AGENDA
PLANNING COMMISSION
116 WEST NEEDLES
BIXBY, OKLAHOMA
April 21, 2014 **6:00 PM**

**MINUTES
PLANNING COMMISSION
116 WEST NEEDLES
BIXBY, OKLAHOMA
March 17, 2014 6:00 PM**

Conceptual Development Plan
EXHIBIT 'A'

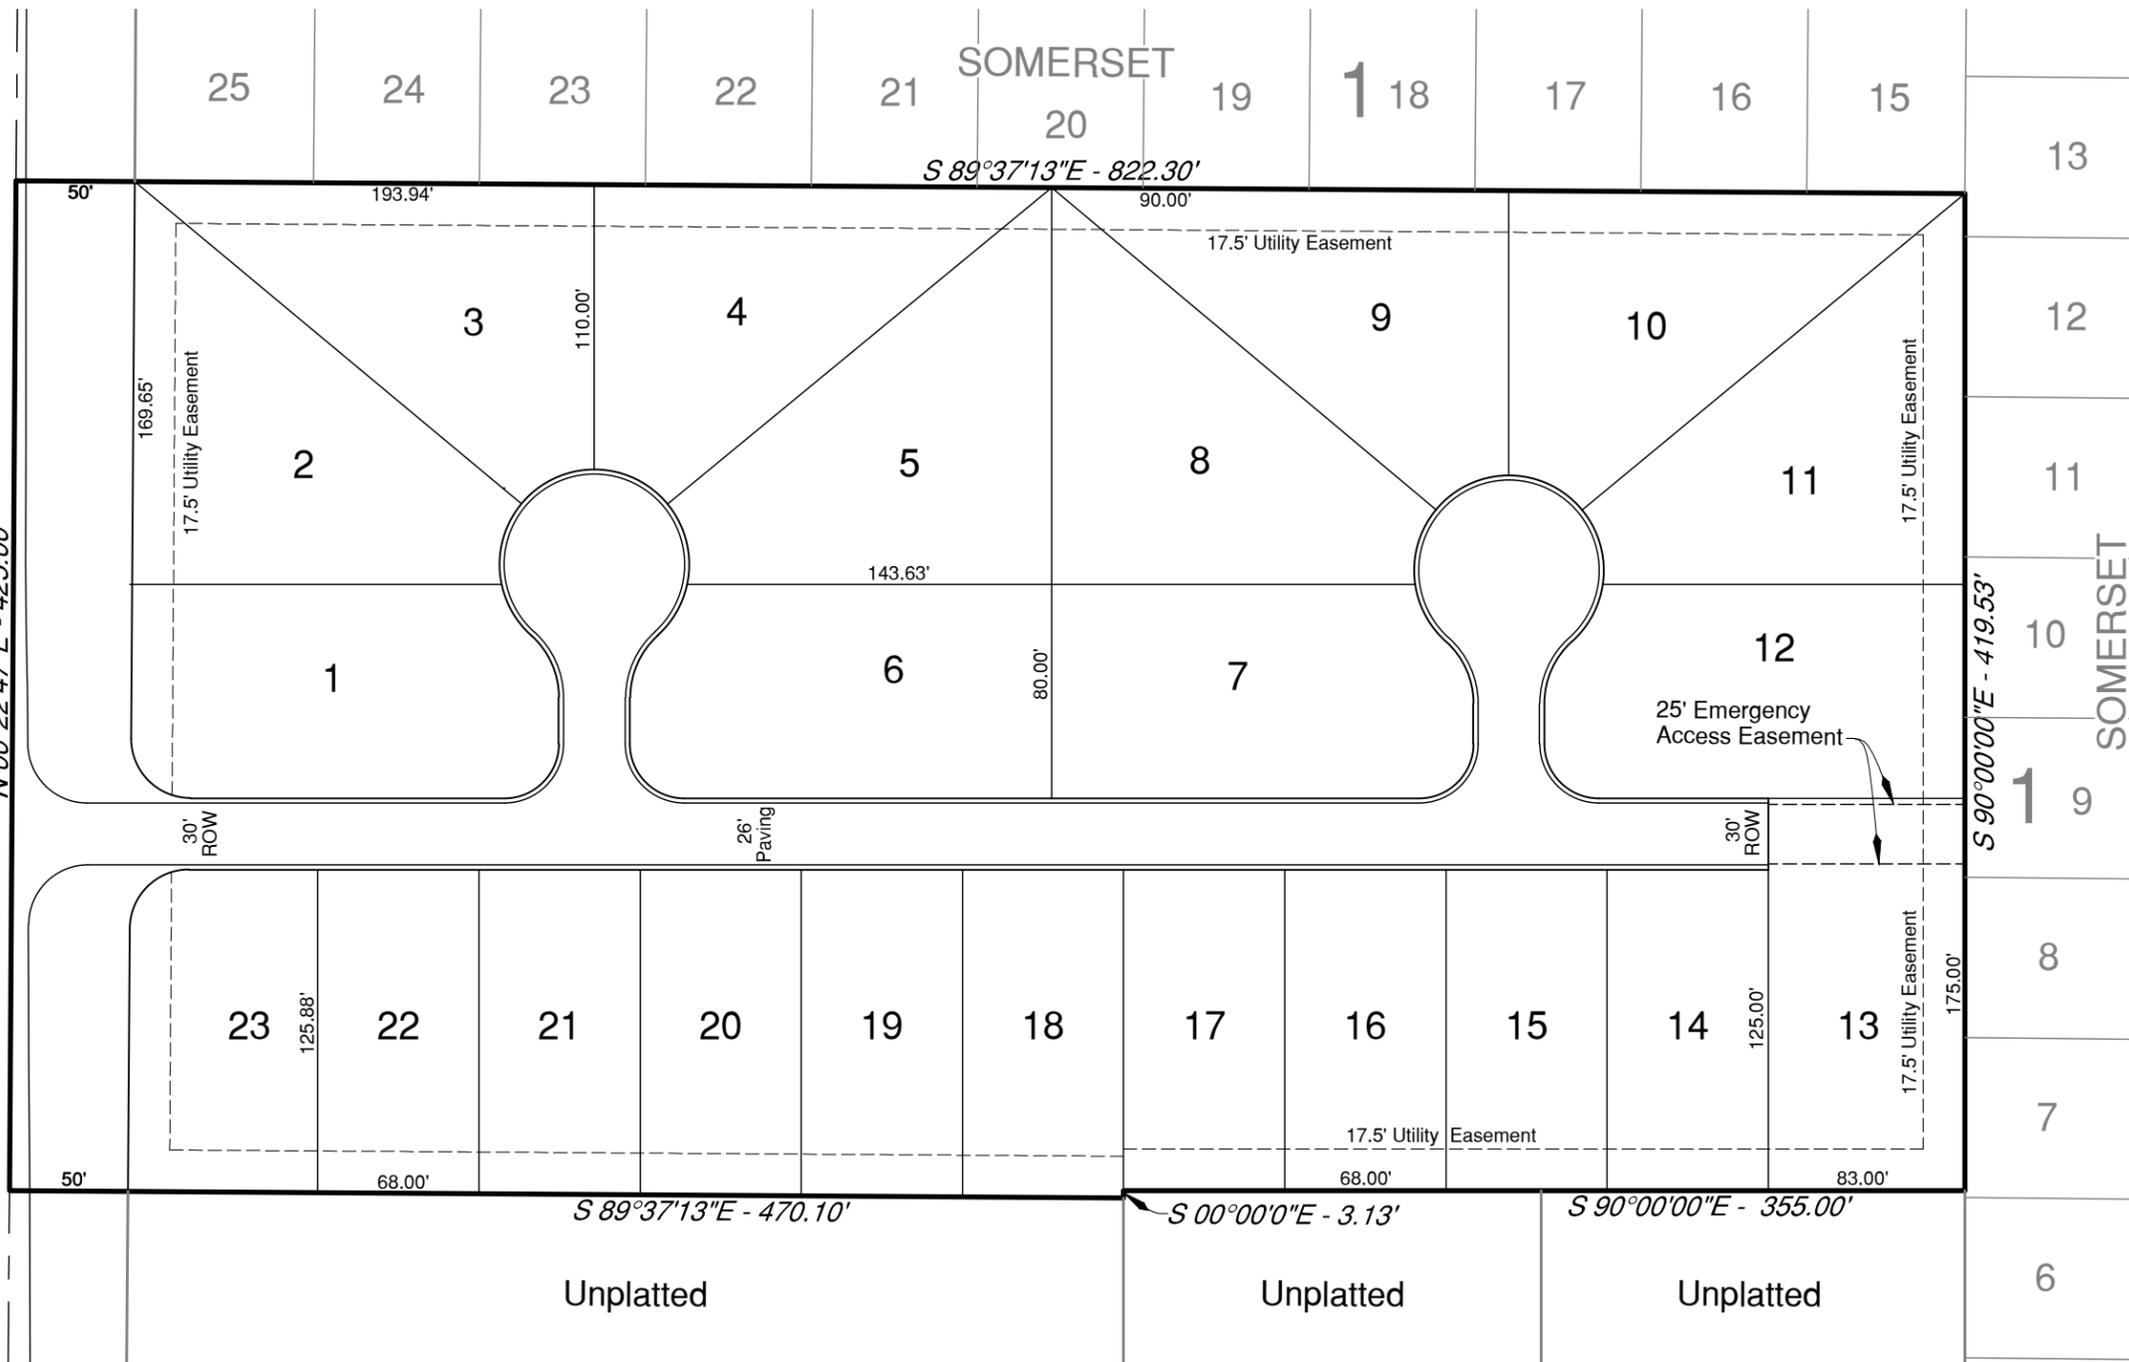
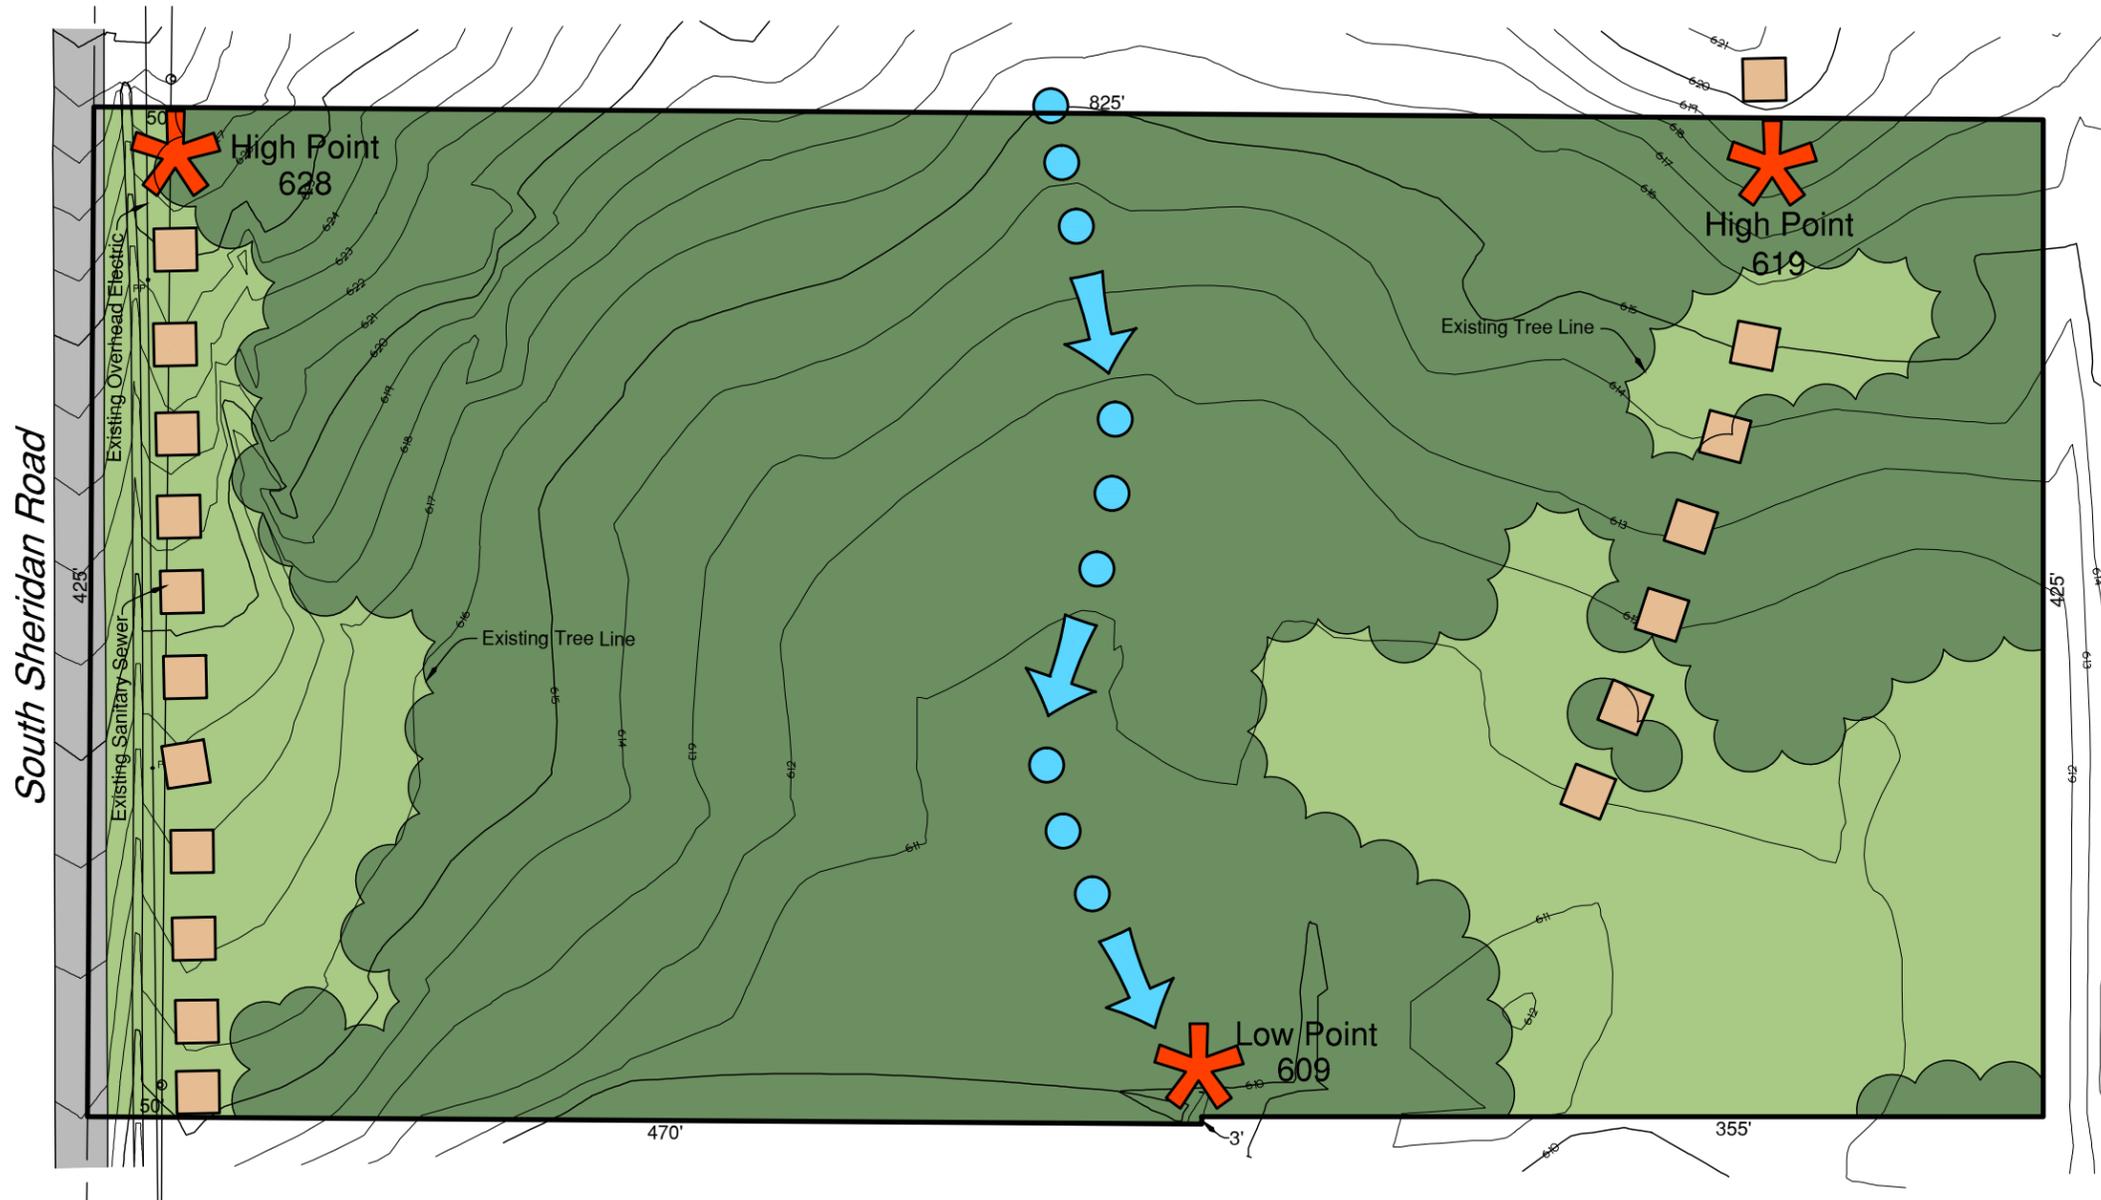
1. Fire Hydrants shall be installed at the main entrance and property line of 15 and 16. All hydrants shall be operable before construction begins.

- Brand- AVK or Mueller , Color- Chrome Yellow
2. Fire line supporting the fire hydrants shall be looped.
3. All roads and Second means of access capable of supporting an imposed load of 75,000 pounds shall be in place before construction of homes. (IFC 2009 Appendix D)

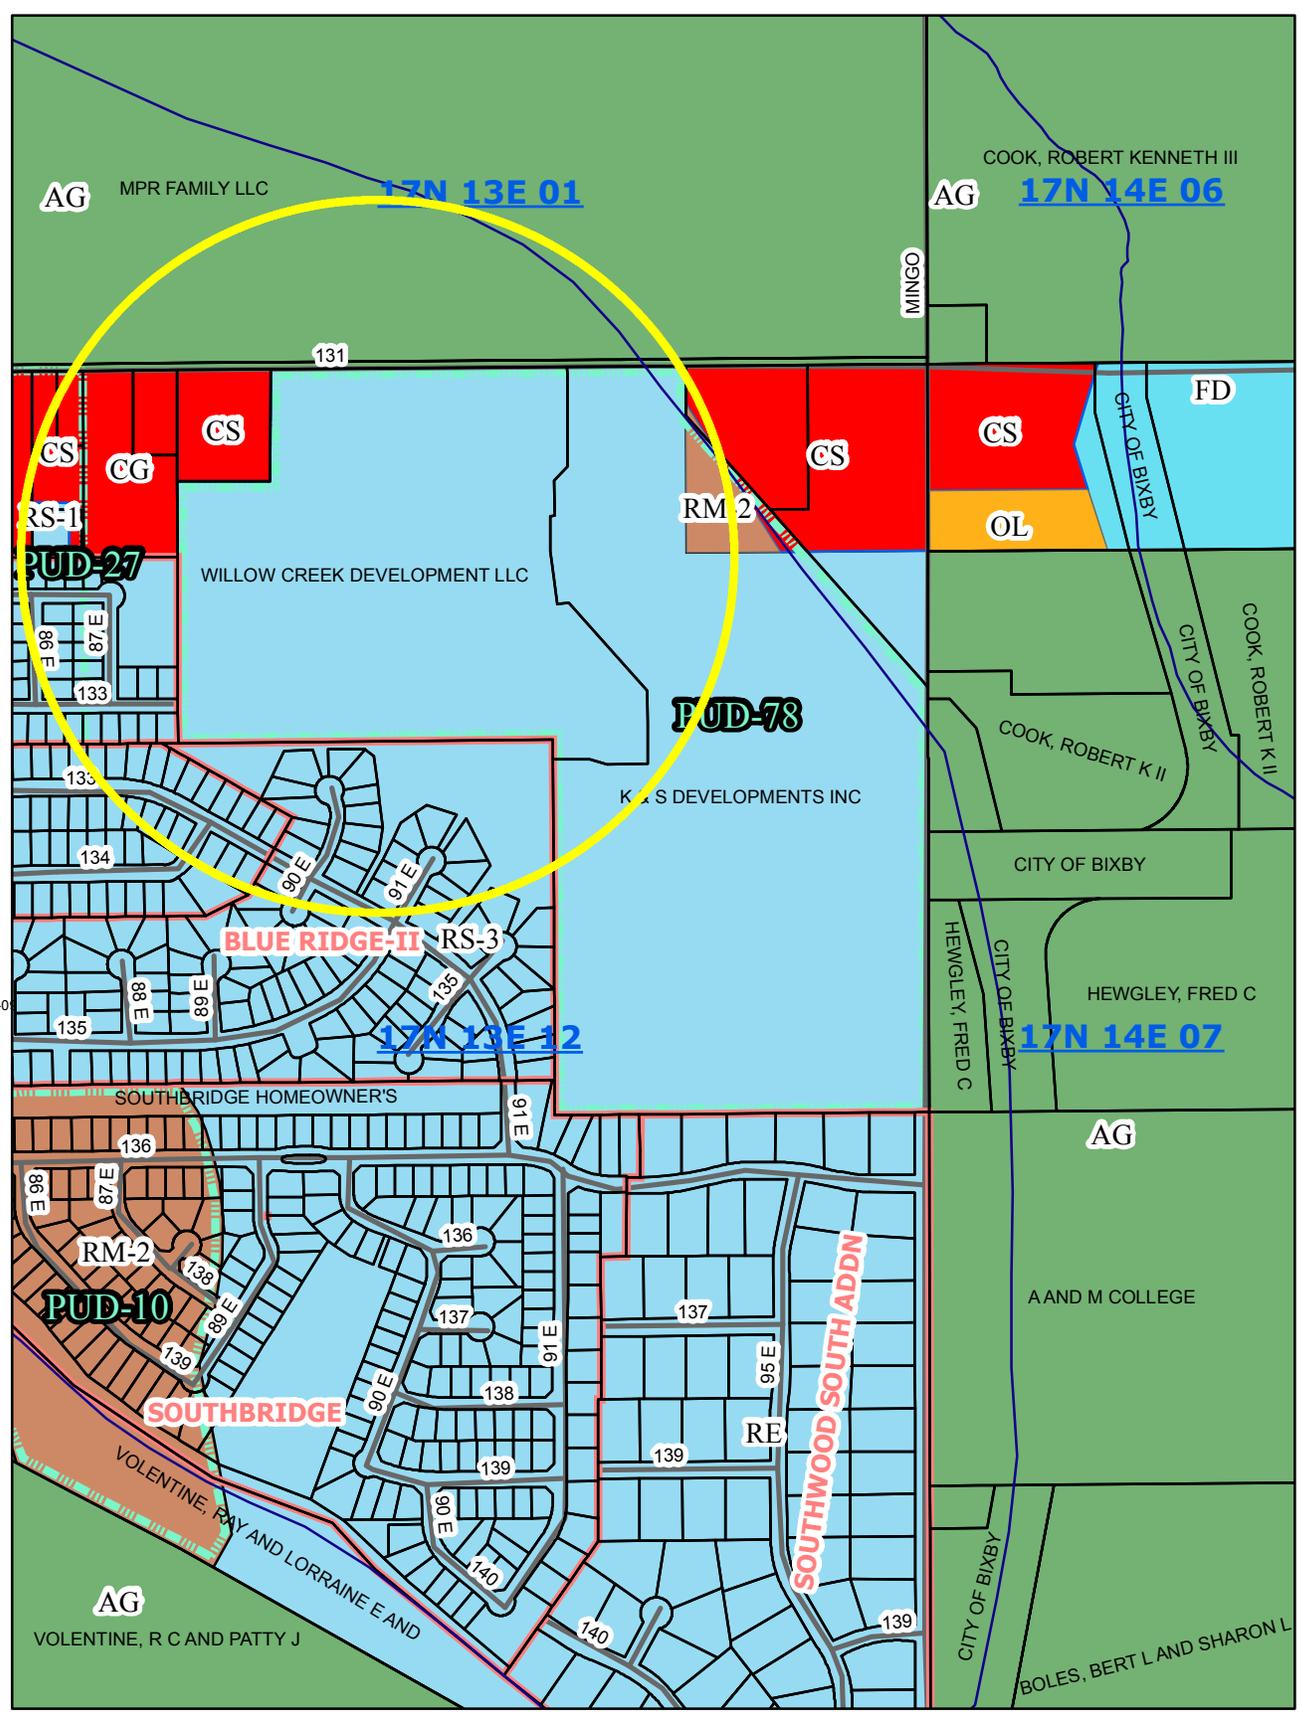
51. Duplication of angle/bearing between lots in which there is no angle/bearing change causes unnecessary congestion. These redundancies can be removed in accordance with customary platting conventions.
52. Lot 34, Block 1 has been extended, but the lot depth dimension has not been updated.
53. "Tick marks" identifying points of tangent and points of curvature are missing.
54. Angle/bearing apparently missing from 27.70' call for U/E in Reserve C.

55. Angle/bearing apparently missing from 38.92' call for along south dead-end of 93rd E. Ave.
56. SRs Section 12-3-2.C requires provision for temporary turnarounds at dead-end streets. A temporary cul-de-sac easement is not represented at the south dead-end of 93rd E. Ave., and provisions for same are not found in the DoD/RCs (e.g. providing for their public access, maintenance, defeasibility upon future extension of the street, etc.).

57. Consider making the common lot line between Lots 4 and 5, Block 1, coterminous with the south/westerly endpoint of C4 in order to eliminate the 2.35' variance between the south/westerly endpoint of C4 and the common lot corner. It is not clear on which side of the common lot corner the 2.35' variance is located, due to its exceptionally small size and the scale of the plat.

'FINAL PLAT'
Wood Hollow Estates
A SUBDIVISION OF PART OF THE
S/2 OF GOVERNMENT LOT 4 OF SECTION 2, T-17-N, R-13-E
CITY OF BIXBY, TULSA COUNTY, OKLAHOMA
Planned Unit Development Number 80

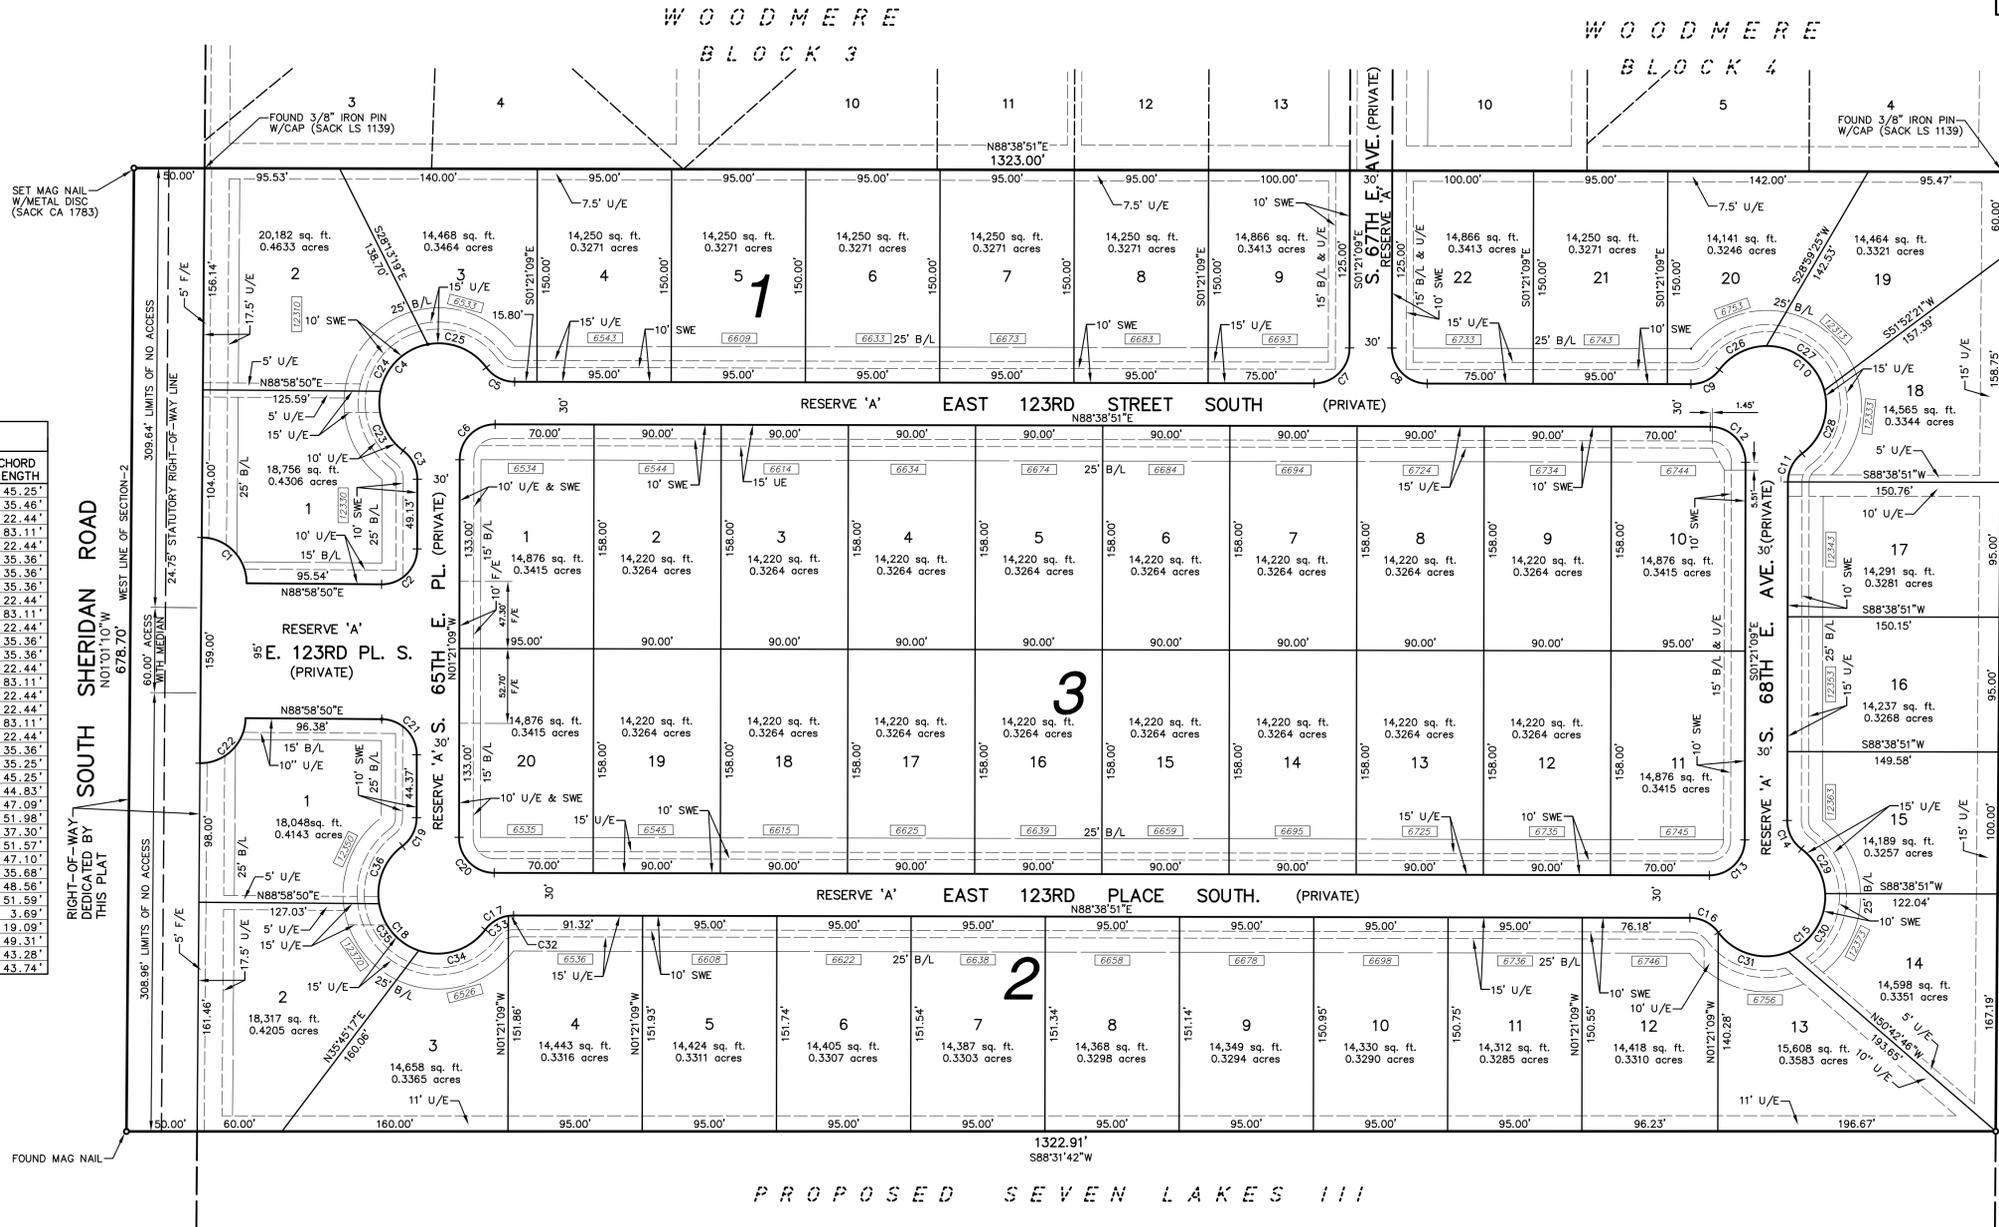
1. Reduced Perimeter U/E widths as follows: 7.5’ on the north, 15’ on the east, 11’ on the south, and (as has been proposed all along) 17.5’ on the west

Erik, Welcome back and congratulations on your race in St. Louis. We met with Bea and Jared yesterday and came to an agreement on the easement widths - 7.5' on the north, 15' on the east, and 11' on the south. With this agreement we would like to ask the City Council to reconsider their motion and approve the final plat with the easements as agreed too.

2. Amendment document Section C must cite the date of the final version of the Final Plat incorporating the new U/E width arrangements as specified above.
3. Amendment document Section D.2 should be clarified as follows: “Modify enclosed off-street parking...”
4. Recognizing matters of preventing precedent, City Staff recommendations, and City Council approval circumstances, this Minor Amendment must also be approved by the City Council.
